# TECHNICAL BULLETIN

No. 407-07-78

**MODEL AFFECTED:** 407

**SUBJECT:** AFT FUSELAGE BULKHEAD 407-030-027-101  
AT FS 231.4, INTRODUCTION OF.

Figure 1. Installation of aft fuselage bulkhead (sheet 1 of 4)

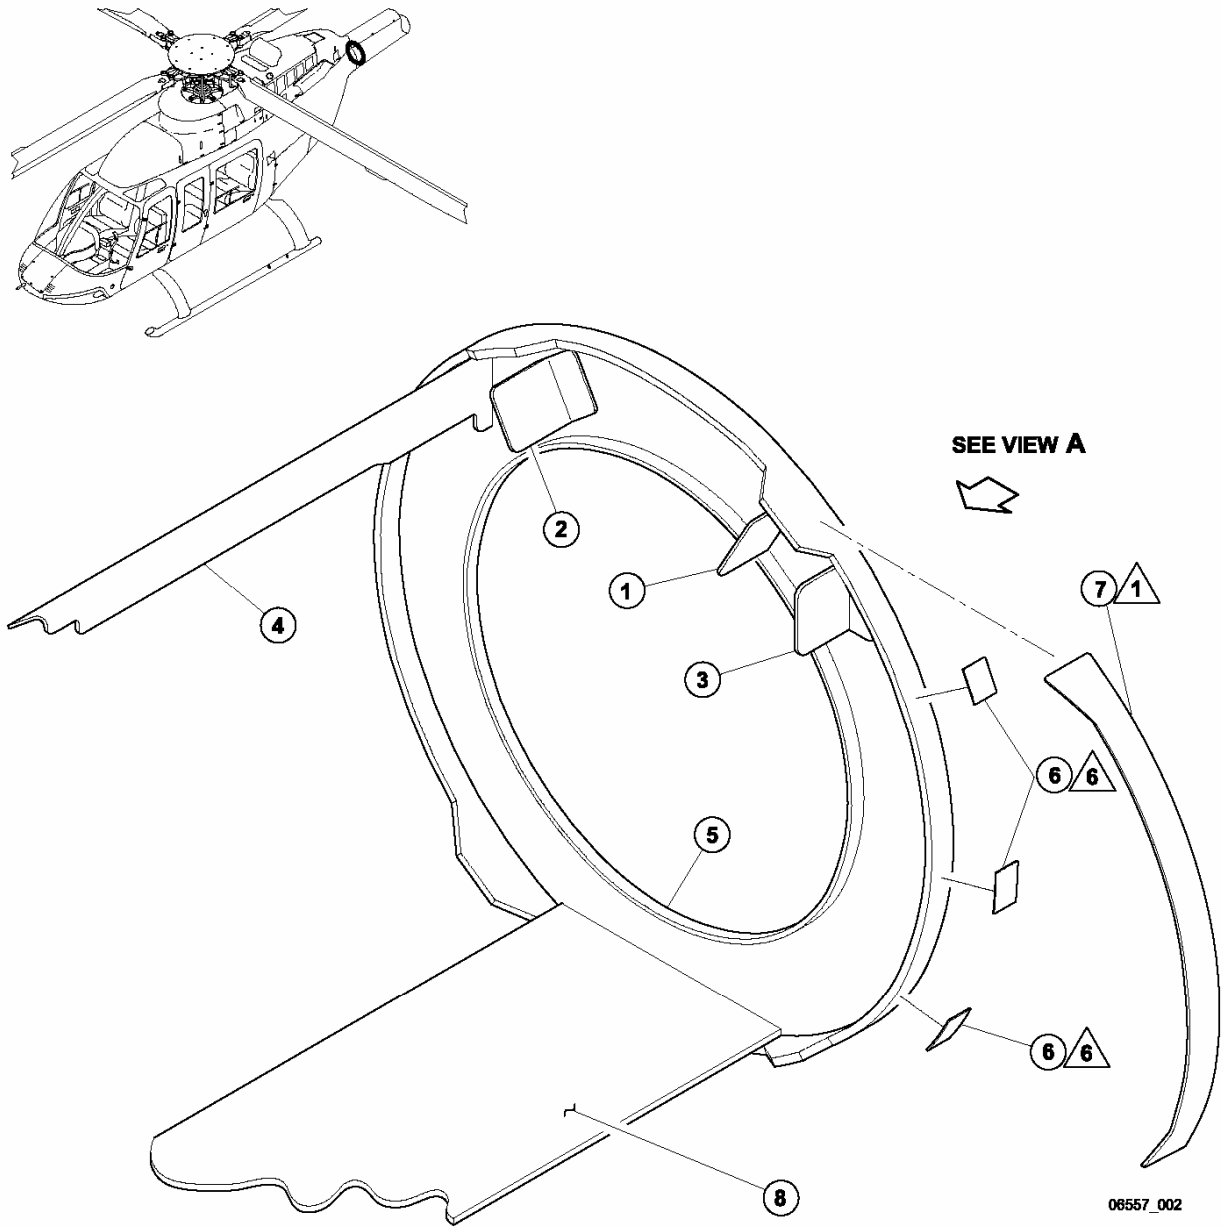
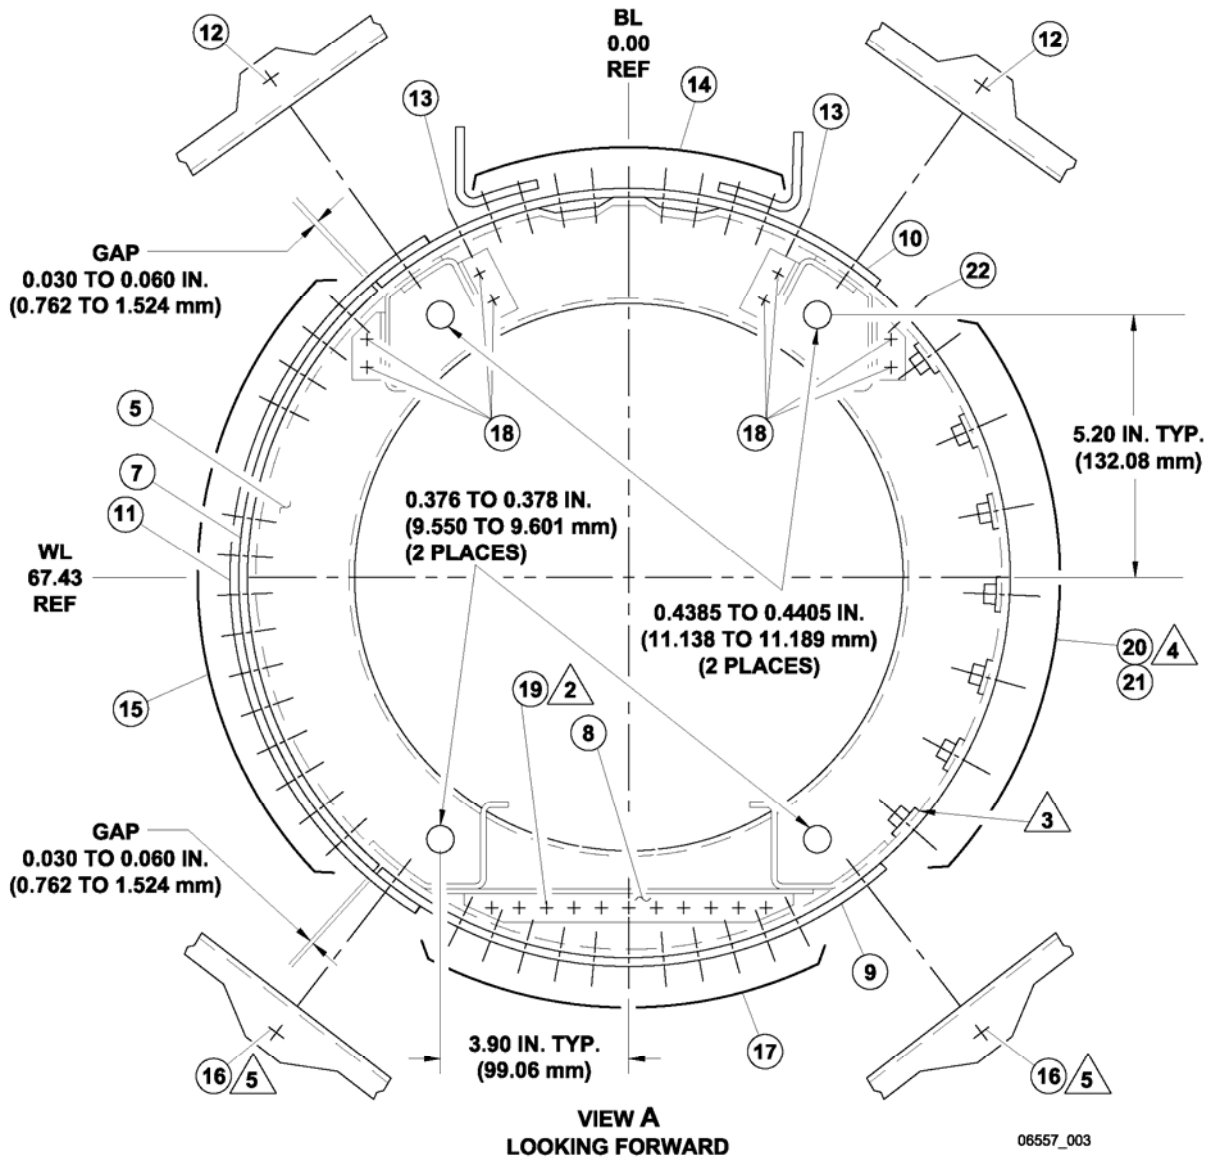
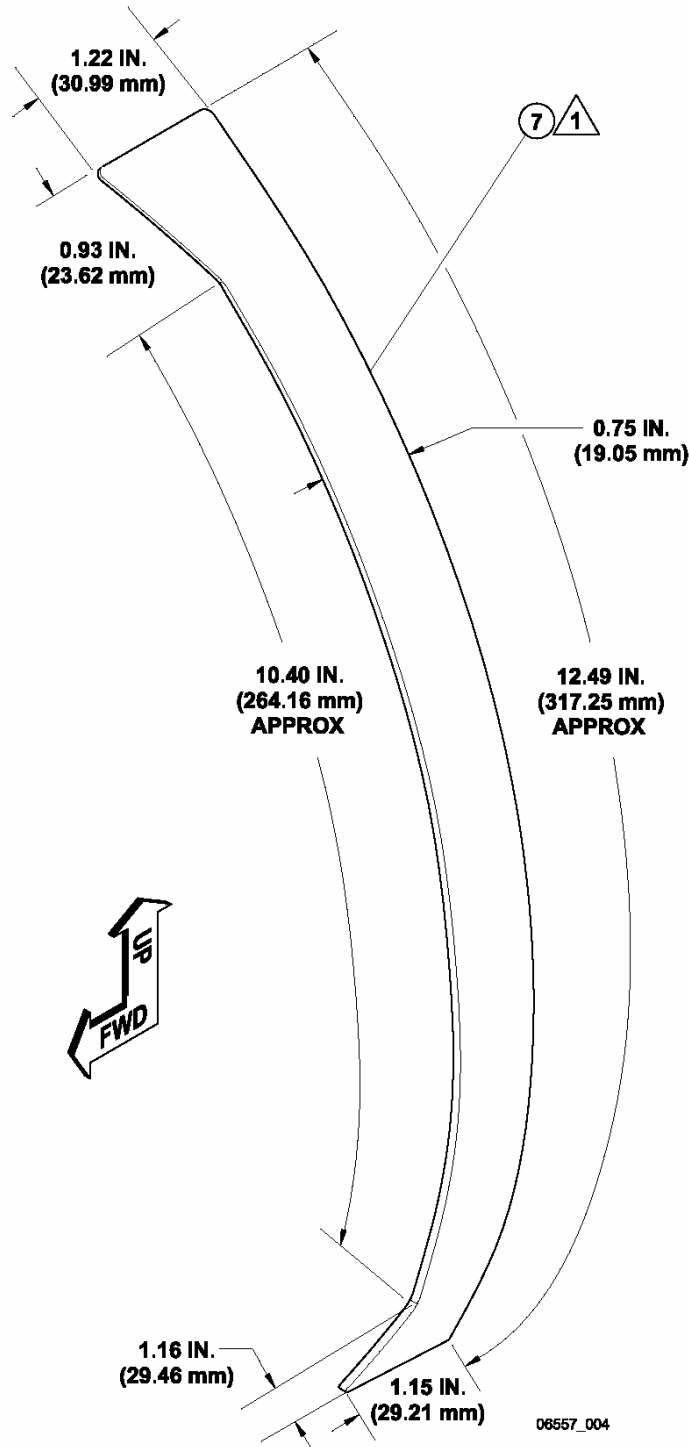
Bell Helicopter recently introduced a new machined aft fuselage bulkhead. This improved bulkhead is made of aluminum with thicker material in bend radius for better fit and reliability. This bulkhead can be used on all 407 model helicopter as a spare replacement.

1. At FS 231.4, remove the aft bulkhead (5) from the fuselage as follows:
  - a) Refer Figure 1, View A. Drill and remove 9 rivets (14), 2 rivets (13) and 2 rivets (12) securing upper skin (10), and both upper longeron/fittings.
  - b) Remove 2 Hi-lok pins (16) securing both lower longeron/fittings.
  - c) Drill and remove 16 rivets (15) securing L/H aft skin (11).
  - d) Drill and remove 11 rivets (17) securing lower fairing (9).
  - e) Drill and remove 11 rivets (19)securing web (8).
  - f) Drill and remove 1 rivet (22) securing R/H angle support (4).
  - g) Drill and remove 8 rivets (18) securing clips (1)(2)(3) and angle support (4) to aft face of bulkhead (5).

1. Refer to Figure 1. Install new aft fuselage bulkhead (5) into position.
2. Measure gap between L/H aft skin (11) and bulkhead (5). Record value.
3. Fabricate shim (7) from 2024T3 or 6013T4 aluminum material to dimension shown in Figure 1 and thickness to the value recorded in step 2. Maximum shim thickness not to exceed 0.080 inch. Taper as required to a minimum of 0.005 inch.
4. position shim on L/H of bulkhead and trim as required to obtain a gap of 0.030 to 0.060 inch at each extremity

- b. Reinstall solid shims that were retained in Part I step 1 if same gap condition exists.
14. Refer to Figure 1. Do not drill holes for nutplates (22) and holes for rivet (19) at this time. Transfer all rivet holes from the aft fuselage to the bulkhead (5) and install clecos.

**Figure 2. Installation of portable drill plate (sheet 1 of 2)**

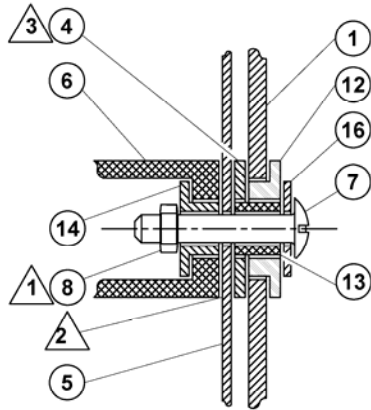
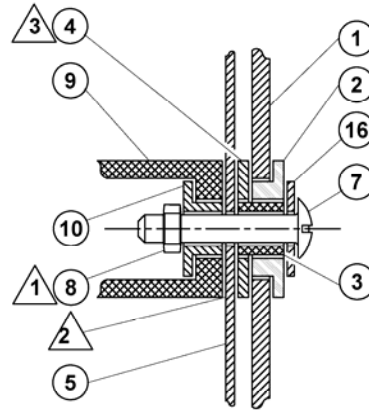
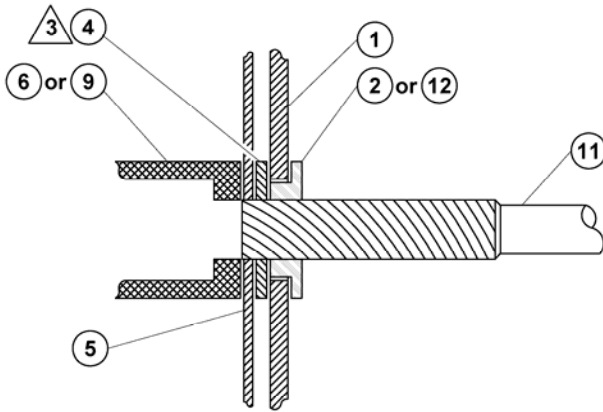
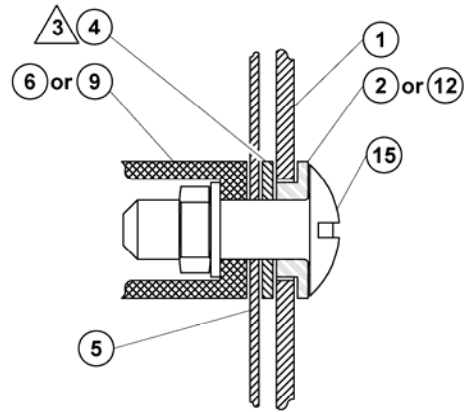
1. Refer to Figure 2. Install new aft bulkhead (5) into position. Refer to View A, attach drill plate (1) using bushings (12) (13) (14) to aft fuselage at upper left and right fittings (6). Refer to View B, attach drill plate (1) using bushings (2) (3) (10) at lower left and right fittings (9) Torque all bolts (7) and nuts (8) to 50 in-lbs.
2. Refer to Figure 1. Measure gap between L/H aft skin (11) and bulkhead (5). Record value.
3. Fabricate shim (7) from 2024T3 or 6013T4 aluminum material to dimension shown in Figure 1 and thickness to the value recorded in step 2. Maximum shim thickness not to exceed 0.080 inch. Taper as required to a minimum of 0.005 inch.
4. Position shim on L/H of bulkhead and trim as required to obtain a gap of 0.030 to 0.060 inch at each extremity.

7. Refer to Figure 2, remove bolt (7), nut (8), bushings (3 and 10) from the lower R/H fitting (9). Drill by increasing size of drill bit until you can final ream bulkhead (5) to 0.376-0.378 inch. Install a 3/8 bolt size and nut, and torque to 50 in-lbs.

5. Temporarily secure bulkhead (5) to each longeron/fitting with C-clamp.
6. Refer to Figure 2, View B. Install flange bushing (10) in both lower longeron/fitting. Backdrill size 0.187/0.189 inch from longeron into the bulkhead (5). Those holes are the new pilot holes.
7. Remove the bulkhead (5) from fuselage. On a bench, install bushings (2) and (3) in drill plate for the lower longeron/fitting holes. Attach bulkhead to drill plate using new pilot holes drilled in step 6 with 3/16 bolt and nut. Torque to 50 in-lb. Secure bulkhead to drill plate with C-clamp all around circumference.

**Figure 3. Fabrication of aft fuselage/tailboom portable drill plate**

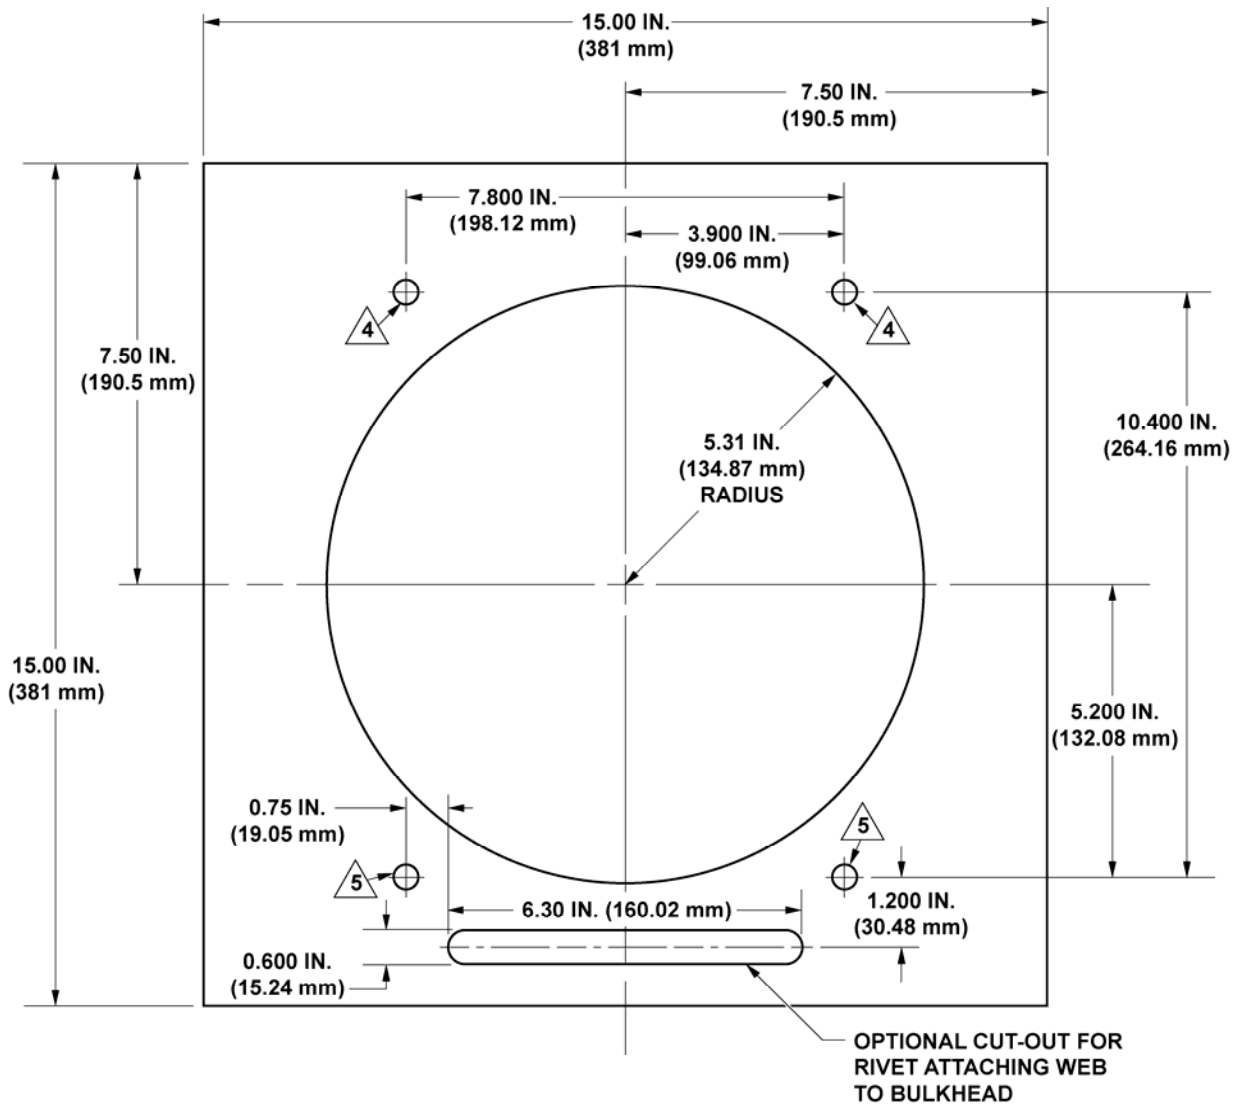
Aft fuselage/tailboom portable drill plate (locally manufactured). Refer to Figure 3.  
Flange bushings and drill bushings. Refer to figure 2 for size required.

- h) Separate bulkhead (5) from aft fuselage structure using a warm thin blade putty knife to release sealant. Remove and discard bulkhead (5) with shims (6).
2. Locally manufacture a drill plate to dimension shown in Figure 3.
